SECTION 00 91 03

ADDENDUM NO. 3

CSM Bldg 2,4 Mod. Project
Bid #86573

Addendum 3

**SINGLE LINE
 DIAGRAM,
 BLDG. 3 BASEMENT
 PLAN**

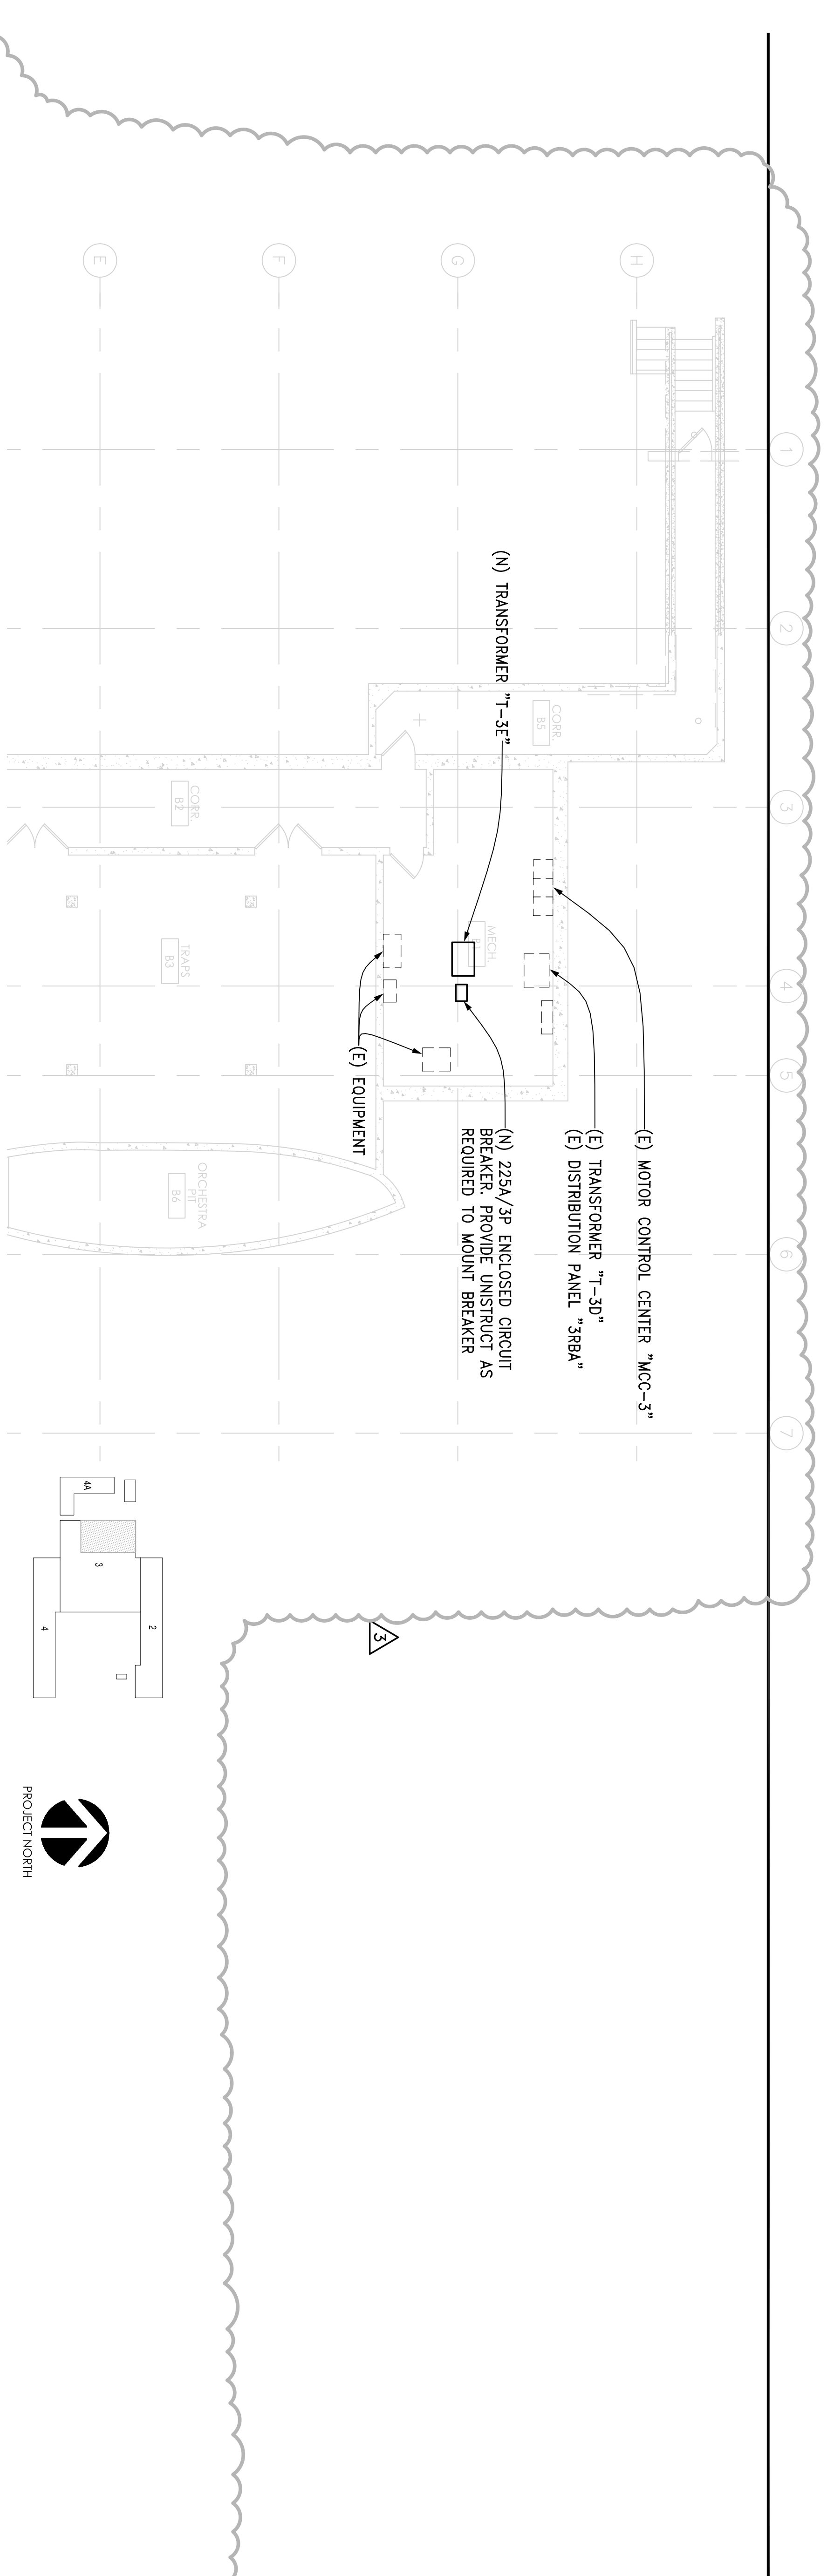
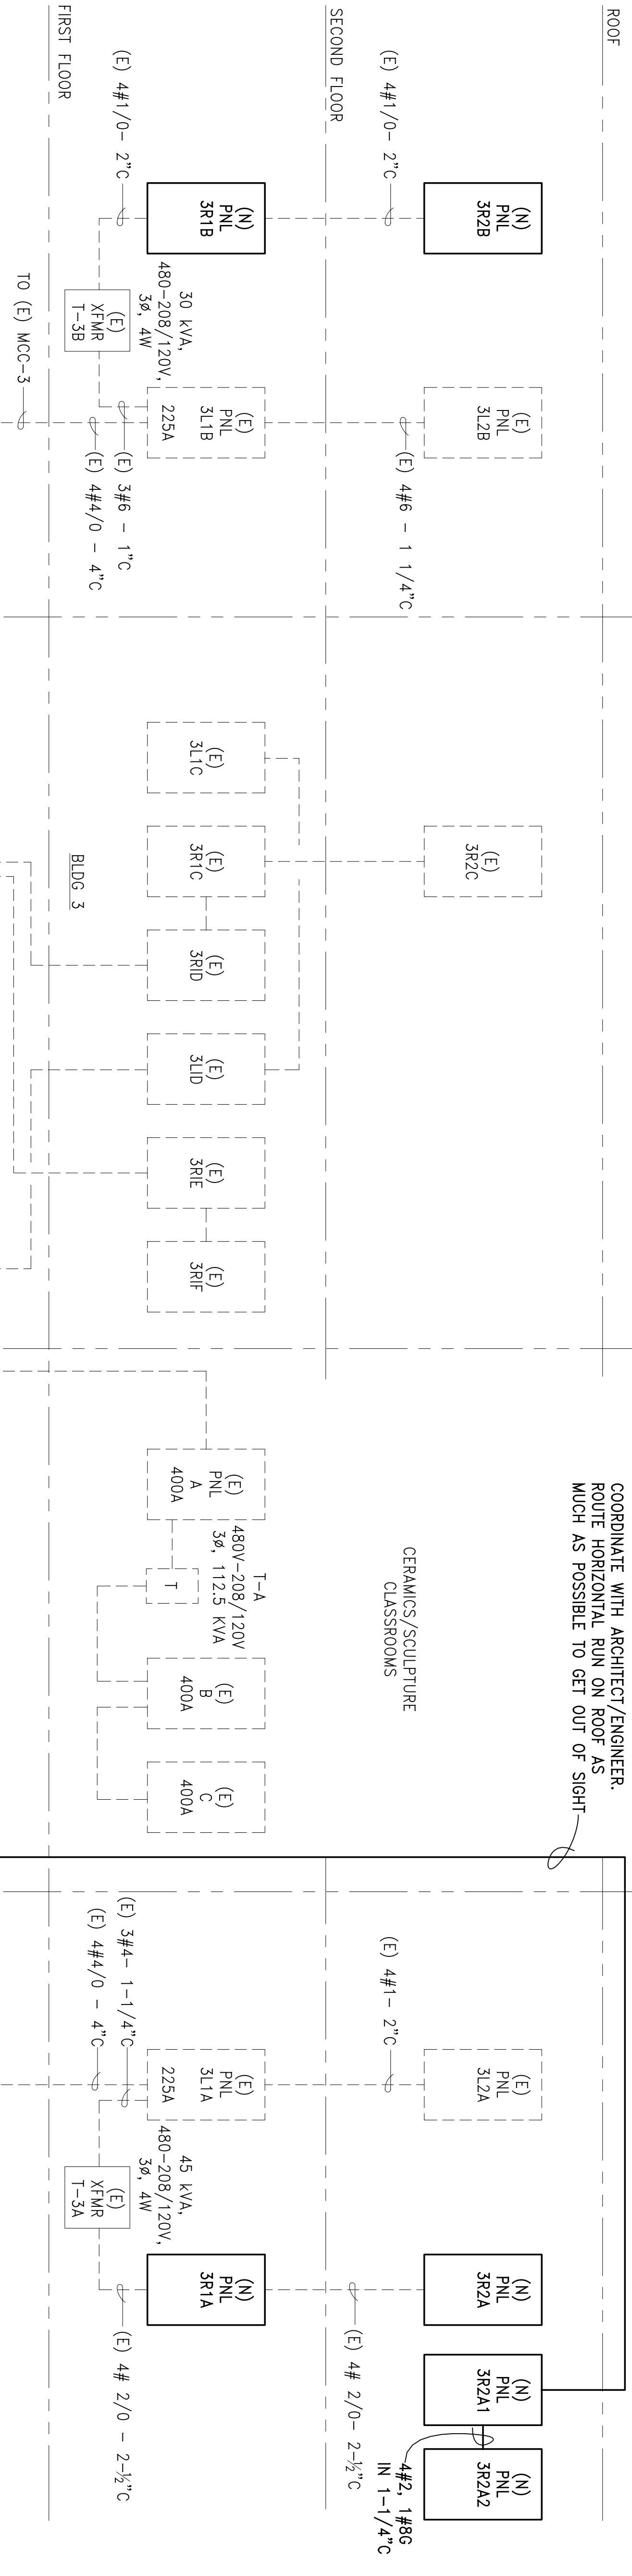
D/E7	Drawing E-500	Detail A1 and C1 <ol style="list-style-type: none"> ADD detail C1 to show work in Mech. Room in Basement. Change feeder size to new panel "3R2A1".

sheet no.
P-111R

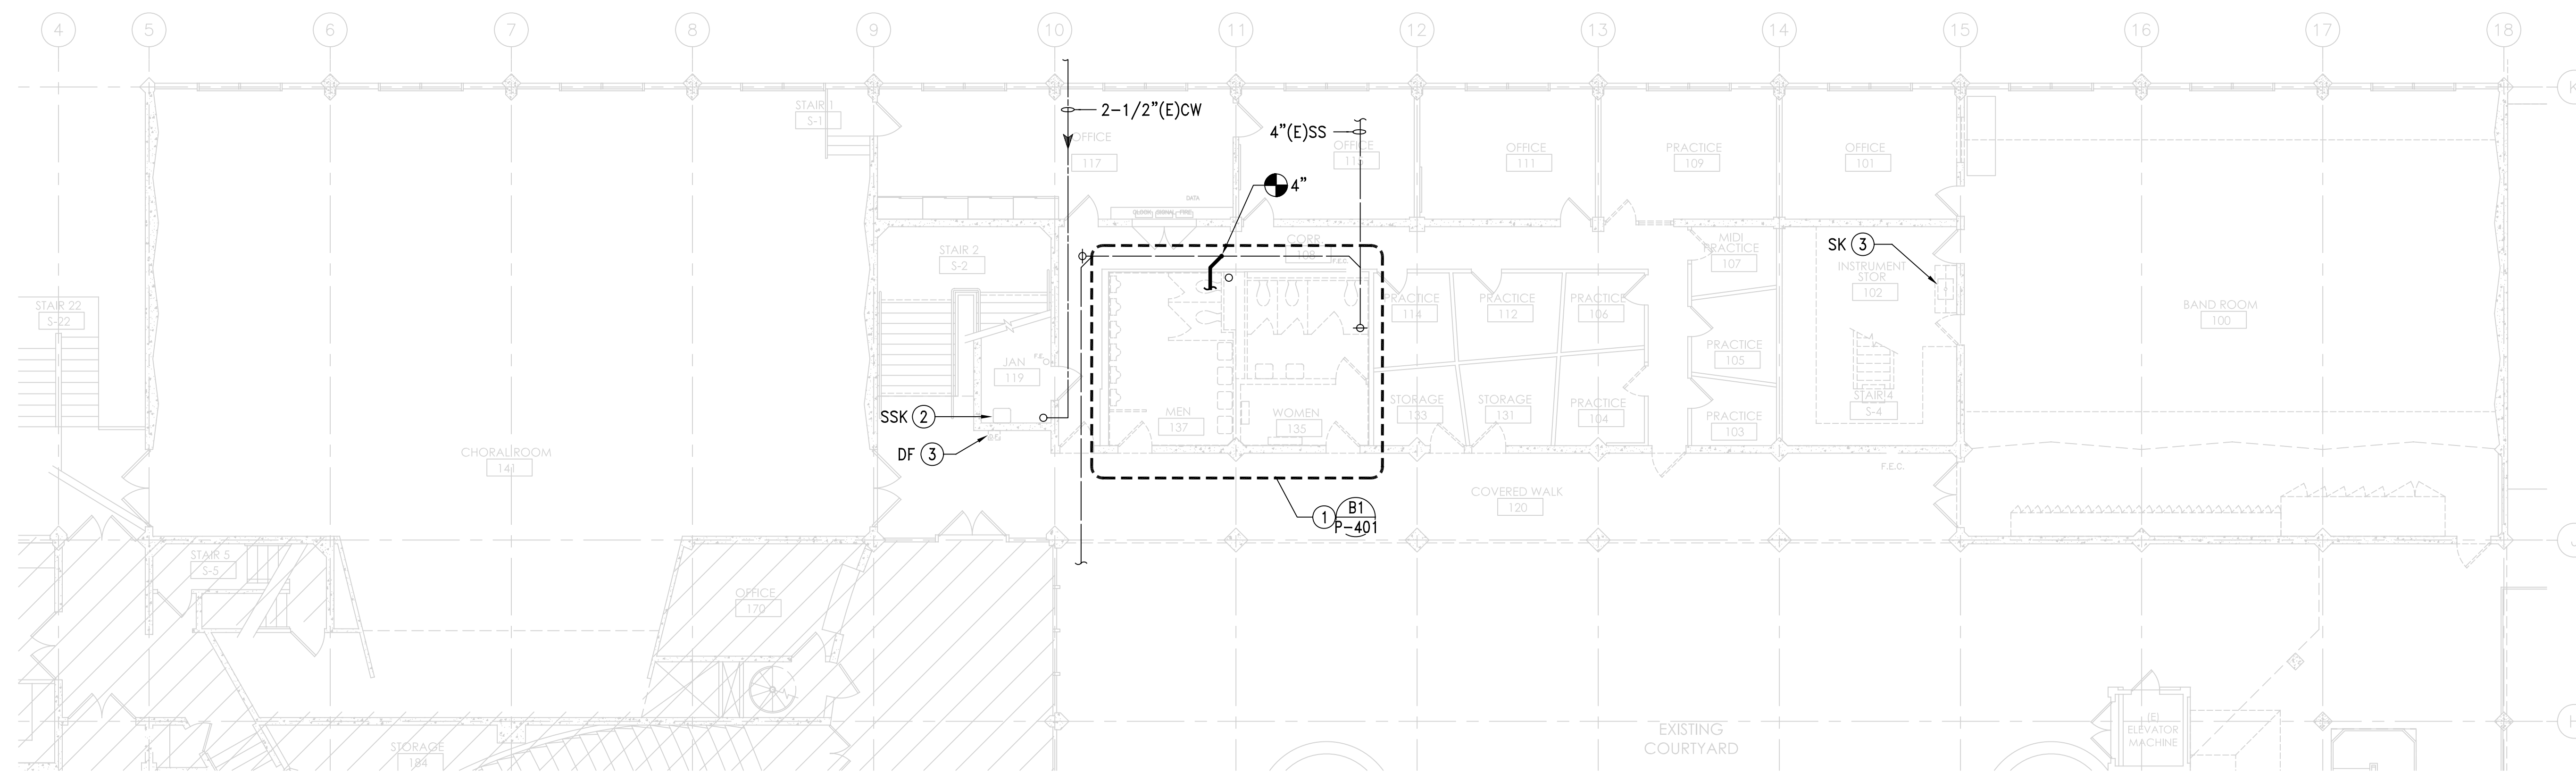
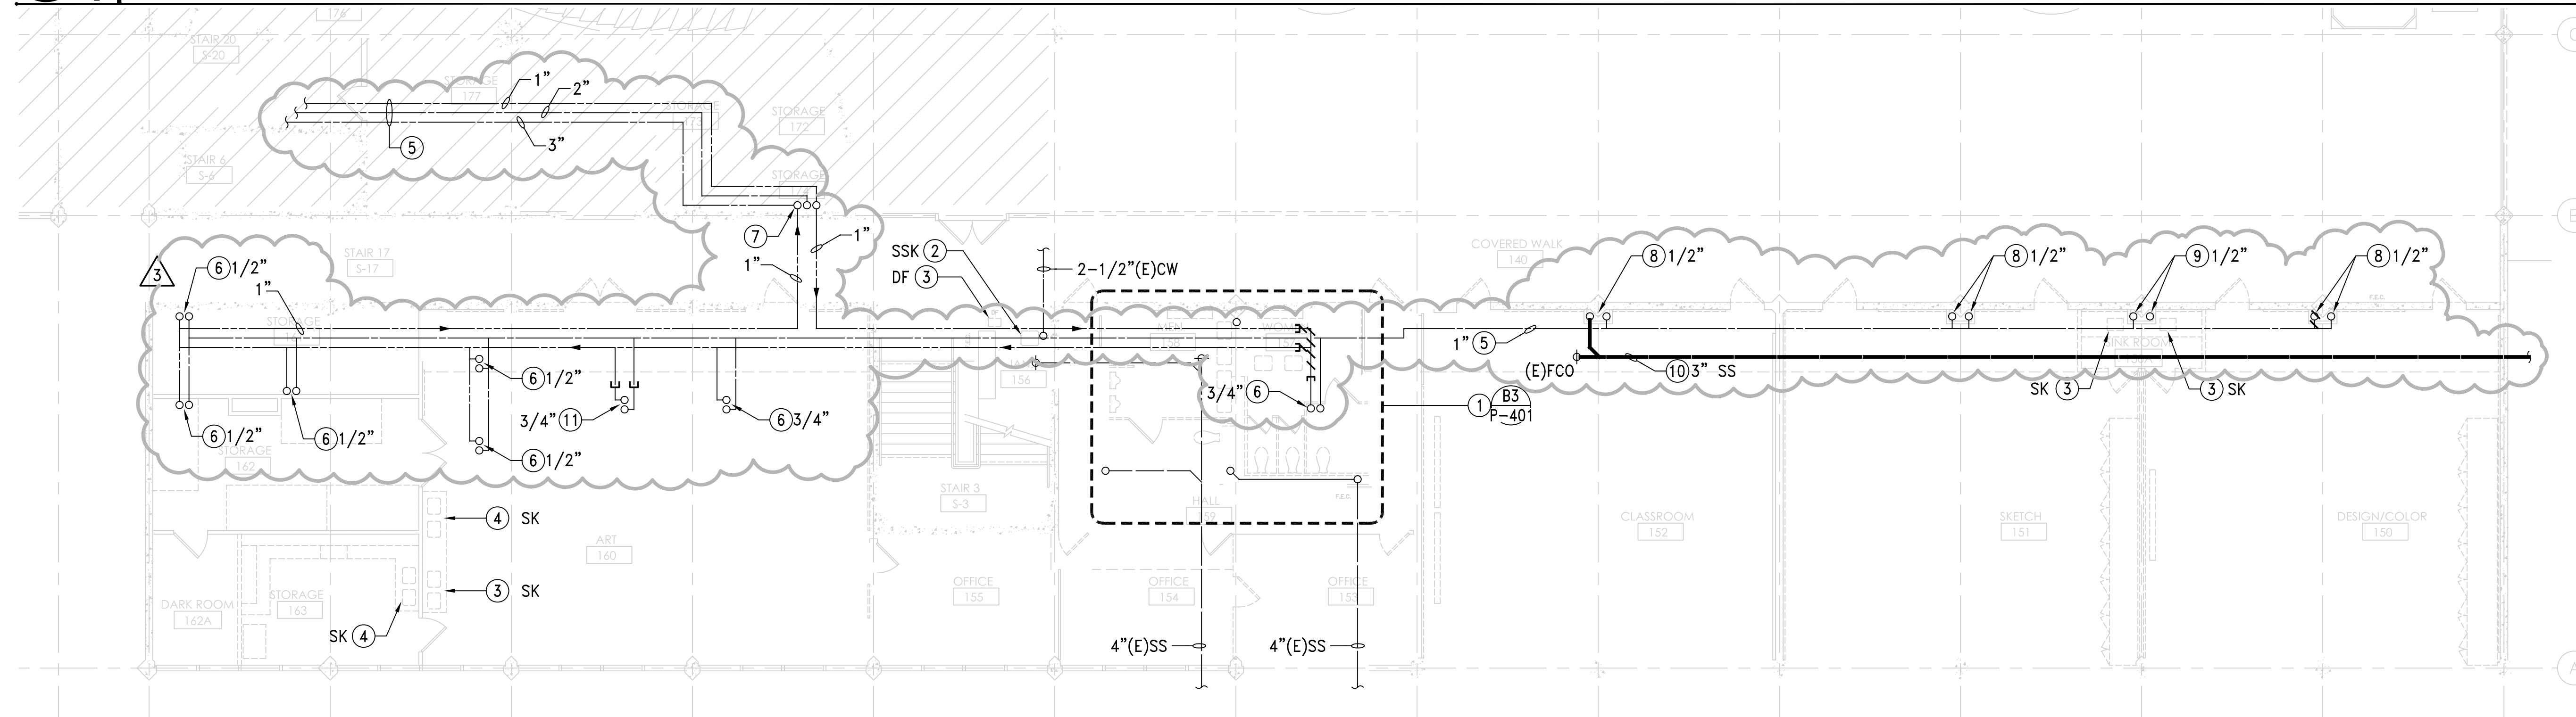
D/P1	Drawing P-001	<ol style="list-style-type: none"> 1. In Plumbing Fixture Schedule, ADD sediment trap specification for SK-3. 2. In Plumbing Fixture Schedule, ADD new photo sink designation, SK-5.
D/P2	Drawing P-111	<ol style="list-style-type: none"> 1. In Building 4 floor plan, ADD existing hot water, hot water return and cold water piping. 2. ADD new Sheet Notes 5 through 10.
D/P3	Drawing P-112	<ol style="list-style-type: none"> 1. In Building 4 floor plan, ADD existing plumbing risers up from below. 2. ADD new Sheet Notes 6 through 11.
D/P4	Drawing P-211	<ol style="list-style-type: none"> 1. In Building 4, ADD hot water to classroom sinks and lavatories. 2. ADD new Sheet Notes 4 through 12. 3. ADD sediment trap to SK-3 in Art Room 160.
D/P5	Drawing P-212	<ol style="list-style-type: none"> 1. In Darkroom 266, ADD two faucets and mixing valves for existing photo sink designated SK-5. 2. ADD or REPLACE mixing valves for existing photo sinks in Photo rooms 268, 269 and 270.. 3. ADD hot water for classroom sink and lavatory. 4. ADD new Sheet Notes 5 through 12.

- ① SEE DETAIL INDICATED FOR WORK.
- ② (E) PLUMBING FIXTURE TO REMAIN. NO WORK IN THIS ROOM/AREA.
- ③ REMOVE (E) PLUMBING FIXTURE. CAP (E) ROUGH-INS FOR NEW WORK.
- ④ REMOVE (E) PLUMBING FIXTURE, AND CAP (E) ROUGH-INS BEHIND FACE OF WALL.
- ⑤ (E) PIPING ABOVE TO REMAIN.
- ⑥ (E) HW & CW UP TO 2ND FLOOR TO REMAIN.
- ⑦ MAIN RISERS UP TO WATER HEATER ABOVE, 1" HWR, 1-1/2" CW, 1-1/2" HW.
- ⑧ (E) CW UP TO 2ND FLOOR TO REMAIN.
- ⑨ REMOVE (E) CW DOWN.
- ⑩ (E) PIPING BELOW FLOOR.
- ⑪ CAP (E) PIPING.
